MOONEY AIRCRAFT, INC. (FAA Approved)

This Service Letter reidentified as
Service Bulletin M 20-100
per Service Instruction M20-15.

SUBJECT: Inspection and Rework of Skin Joint, Wing Station 59.250

MODELS AFFECTED: M20B, Serials 1702 through 1763, except for the following numbers:
1703, 1708, 1709, 1710, 1711, 1715, 1730, 1731, 1750, and 1759

FIGURE 1

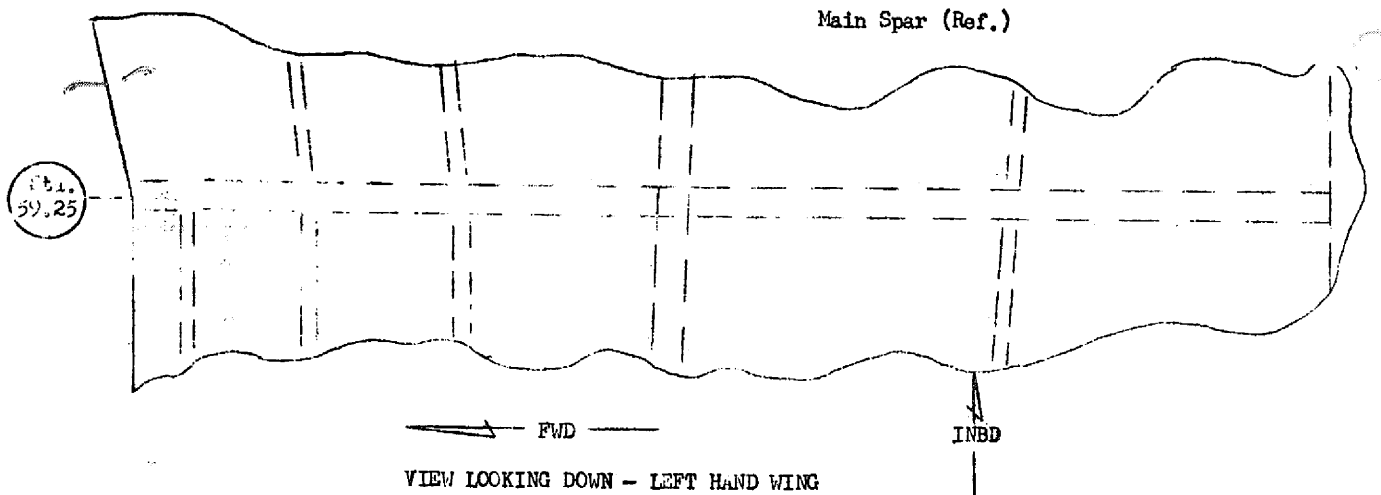
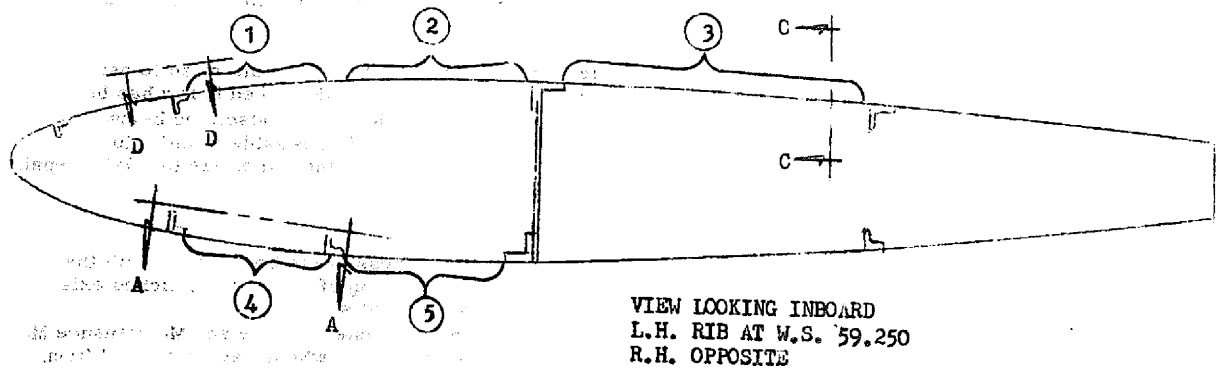
Inspect the rivets in the areas shown on Figure 1 for signs of loosening. Loose rivets are characterized by black oxide which seeps between rivet and skin to the surface. This oxide may leave a slight streak in the direction of the air stream if the rivet has been loose for some time. In any event, if black oxide is present, it will be noticeable by simply passing a finger or white cloth over the head of the rivet.

A maximum of four (4) loose rivets per side in the specified areas will be considered acceptable with no rework necessary. However, it will be necessary to continue this simple inspection every fifty (50) hours or so to assure that no additional rivets become loose. The inspection need not be continued after the rework described below has been accomplished.

If and when more than four rivets per side are found to be loose, all of the rework described below is to be accomplished on that wing. It is considered that the rework on both wings as described is desirable in order to avoid continuing inspection of any area not reworked as well as avoid further inconvenience to the owner due to a later repair.

Replace AN426AD4's with AN426AD5's as per Par. C.II.

Replace AN426AD5's with AN426AD6's as per Par. C.II.

FIGURE 3
(Section C-C)
Area 3

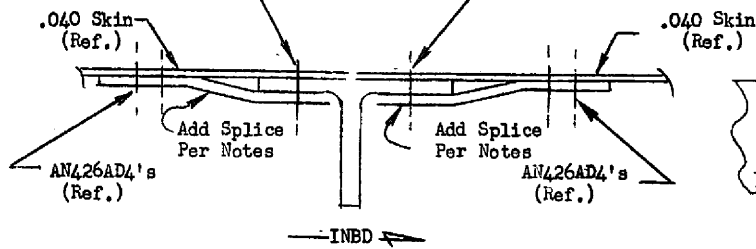
II. Area 3 (Aft of the Main Spar) Ref. Figure 3

Add splices to each side of the upper rib cap as shown. Loose rivets are to be replaced with the next larger size (AD5's with AD6's and AD4's with AD5's) provided that a center-to-center spacing of at least .62 inches exists between AD6's and .50 inches exists on AD5's. If the distance is less than these values, replace with existing rivet size.

FIGURE 4
(VIEW D-D)
(Typ.)

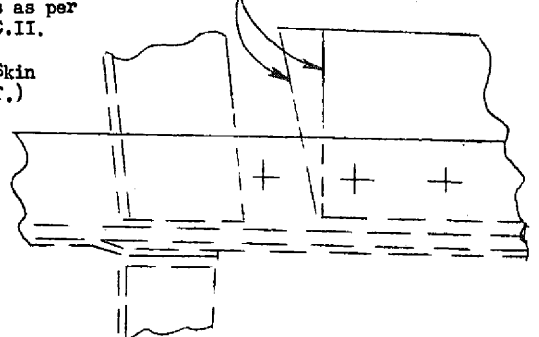
- III. If an edge distance of 2D on rivet at ends of splice adjacent to stringers cannot be maintained, trim end(s) of formed splice such that 2D edge distance on second rivet from stringer can be maintained. See Figure 4.

Optional Trim Line For Splice Plates
